# McLaren Speedtail - Rear Clutch Breather Pipe Rework at 1<sup>st</sup> Service

**Bulletin type:** Service Campaign  
**Reference number:** SCB 23 G 001  
**Attention:** Retailer Service Managers and Retailer Technicians  
**Affected vehicles:** McLaren Speedtail  
**Situation:** Potential for insufficient gap tolerance between components  
**Procedure:** Action affected vehicles during 1<sup>st</sup> Service ONLY. Please refer to the information outlined in this document to ensure required gap tolerance is achieved  
**Date:** 22<sup>nd</sup> April 2021

Clip - Male (1), Swivel Clip - Male + Female (2)

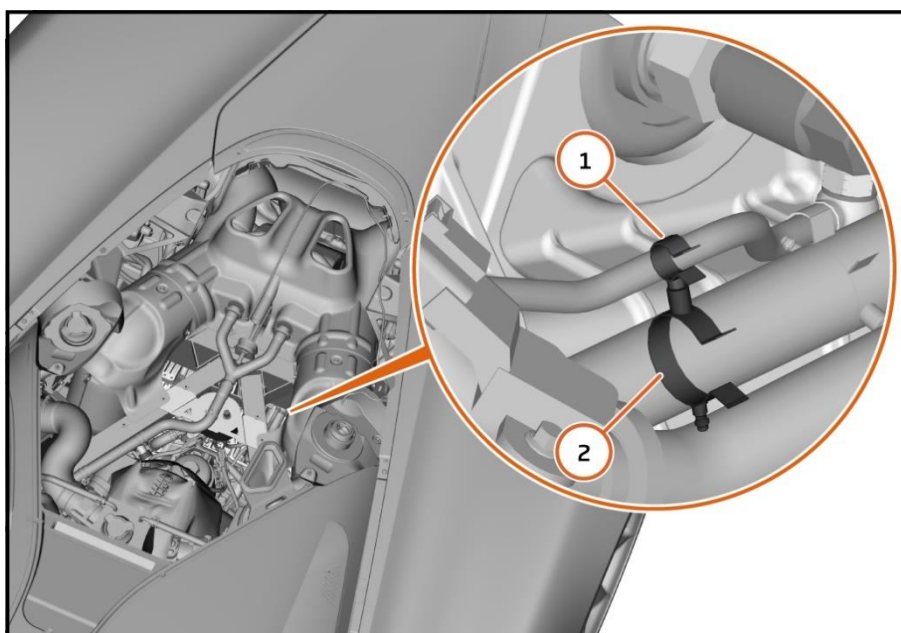
Through continuous product quality monitoring, it has been identified that a number of McLaren Speedtail vehicles, may have an insufficient gap tolerance between the rear clutch breather pipe and the (right hand) secondary air hose. This could cause damage to the components; therefore a preventive rework solution has been released.

These clips are to be installed at 1<sup>st</sup> service, while the airbox is removed (for access to the oil filter housing during servicing of the vehicle).

- 3.1 Remove airbox as part of 1<sup>st</sup> service (GA-RM-05F003-00-002 - Drain/Fill Engine oil).
- 3.2 Install clips together and position between the rear clutch breather pipe and the (right hand) secondary air hose according to the image in section 1, to ensure required gap tolerance between the components.
